CITY OF ALBUQUERQUE

Re: Take 5 Car Wash
10415 Central Ave. NE
Traffic Circulation Layout
Engineer's/Architect's Stamp XX-XX-XX (L21-D059B)

Based upon the information provided in your submittal received 03-10-23, the above referenced plan cannot be approved for Building Permit until the following comments are addressed:

DESIGN REVIEW COMMITTEE	CITY ENGINEER APPROVAL	ZONE MAP NO. Z-99
		CITY PROJECT NO. 000000
		SHEET NO. C8.0

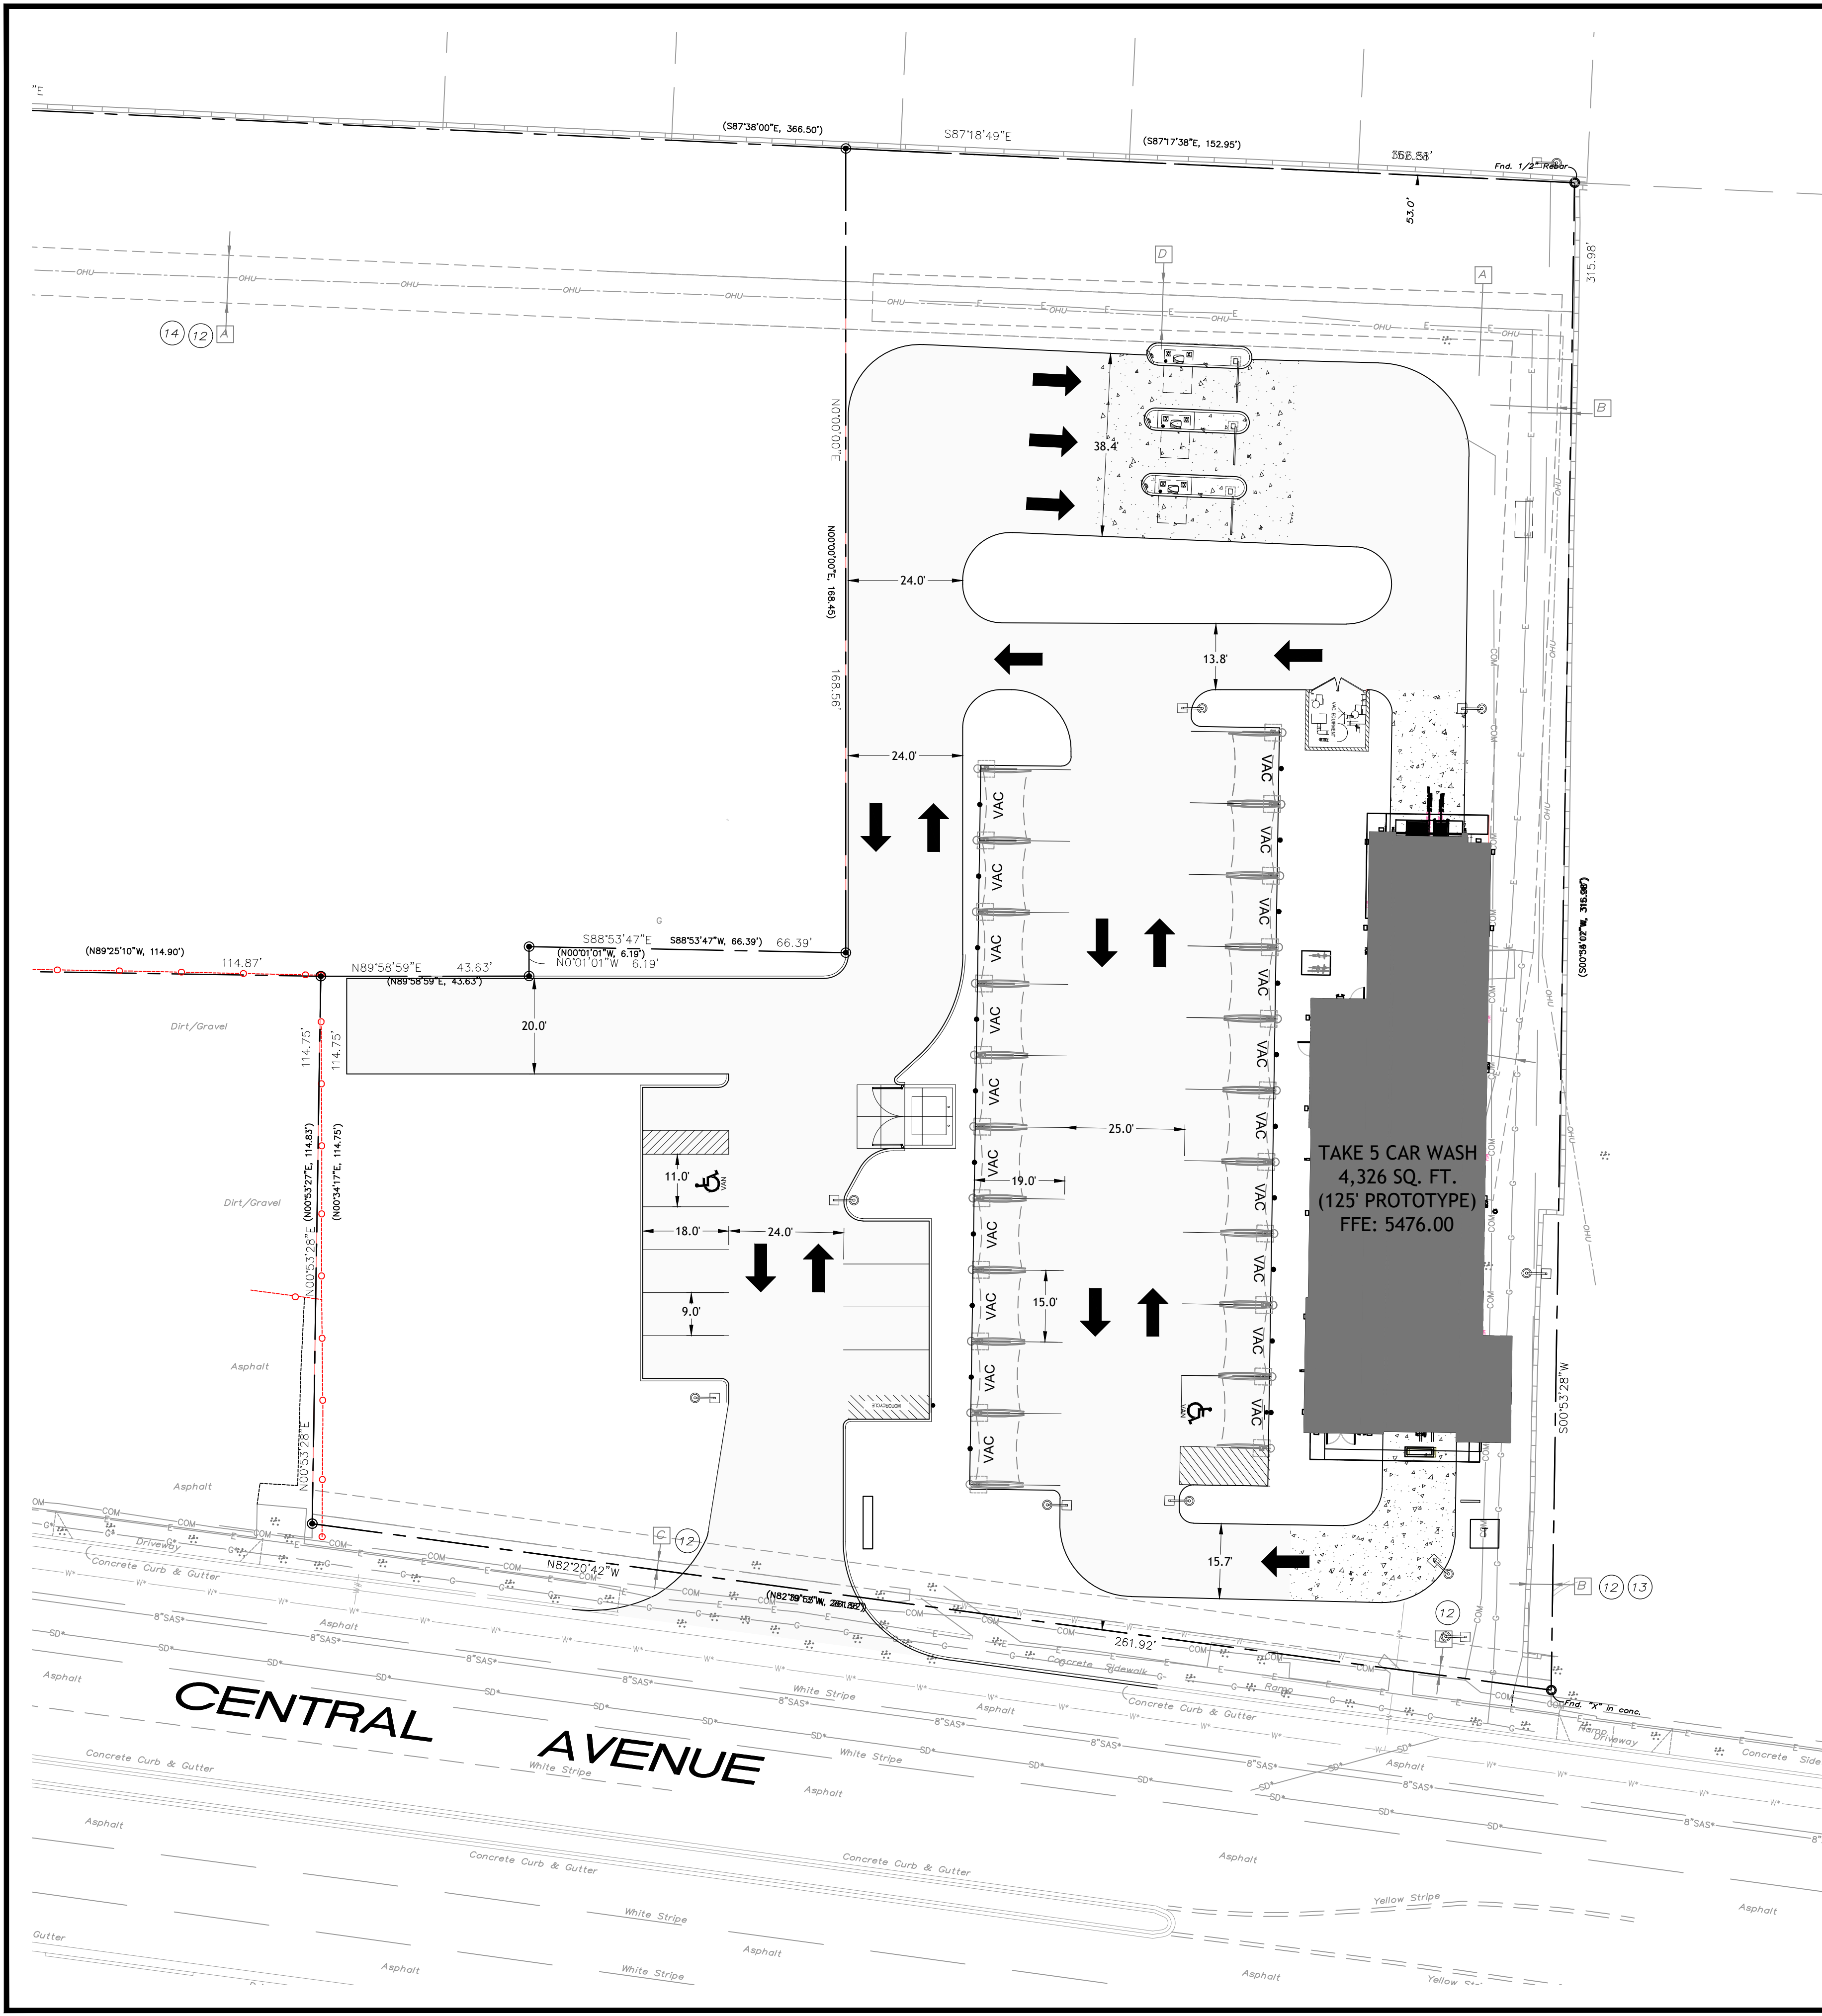
1. The traffic circulation layout must be stamped, signed, and dated by an engineer or architect licensed in the state of New Mexico.
2. Identify all existing access easements and rights of way width dimensions.
3. Identify the right of way width, medians, curb cuts, and street widths on Central Ave.
4. Site access's throat length should be minimum 50 ft. please show this dimension on the site plan.

5. Please provide the width for the existing driveway access off Central.
6. ADA curb ramps at the driveway access must be updated to current standards and have truncated domes installed.
7. The ADA accessible parking sign must have the required language per 66-7-352.4C NMSA 1978 **"Violators Are Subject to a Fine and/or Towing."** Please call out detail and location of signs.

8. The ADA access aisles shall have the words **"NO PARKING"** in capital letters, each of which shall be at least one foot high and at least two inches wide, placed at the rear of the parking space so as to be close to where an adjacent vehicle's rear tire would be placed. (66-1-4.1. B NMSA 1978)

9. Motorcycle parking spaces shall be designated by its own conspicuously posted upright sign, either free-standing or wall mounted per the zoning code.

10. The pavement marking "MC" should be shown in the opposite direction for motorcycles entering the parking space.
11. All bicycle racks shall be designed according to the following guidelines:

- a. The rack shall be a minimum 30 inches tall and 18 inches wide.
 - b. The bicycle frame shall be supported horizontally at two or more places. Comb/toaster racks are not allowed.

- c. The rack shall be designed to support the bicycle in an upright position. See the IDO for additional information.
 - d. The rack allows varying bicycle frame sizes and styles to be attached.

- e. The user is not required to lift the bicycle onto the bicycle rack.
 - f. Each bicycle parking space is accessible without moving another bicycle.

12. Bicycle racks shall be sturdy and anchored to a concrete pad.
13. A 1-foot clear zone around the bicycle parking stall shall be provided.
14. Bicycle parking spaces shall be at least 6 feet long and 2 feet wide.

15. List radii for all curves shown; for passenger vehicles. Radius for delivery trucks, fire trucks, etc. is 25 ft. or larger.
16. Per the IDO, a 6 ft. wide ADA accessible pedestrian pathway is required from the public sidewalk to the building entrances. Please clearly show this pathway and provide details.

17. Per DPM, a 6 ft. wide ADA accessible pedestrian pathway is required from the ADA parking stall access aisles to the building entrances. Please clearly show this pathway and provide details.

18. ADA accessible pedestrian pathway should not be placed behind parking space or adjacent to a vehicular way. Vehicle and pedestrian/wheel chair conflicts should be avoided as much as possible.

19. Refuse vehicle maneuvering shall be contained on-site. The refuse vehicle shall not back into the public right of way.; provide a copy of refuse approval.

20. Provide a copy of Fire Marshal approval.
21. All one-way drives shall have "One Way" and "Do Not Enter" signage and pavement markings. Please show detail and location of posted signs and striping.

22. The minimum drive through lane width is 12 feet with a 25-foot minimum radius (inside edge) for all turns. (A 15-foot radius can be used with an increase in lane width to 14 feet). Please dimension all lane widths and radii.

23. Clear Sight Triangle should start from the back of the sidewalk.
24. Please specify the City Standard Drawing Number when applicable.
25. Add a note stating "All broken or cracked sidewalk must be replaced with sidewalk and curb & gutter." A build note must be provided referring to the appropriate City Standard drawing.
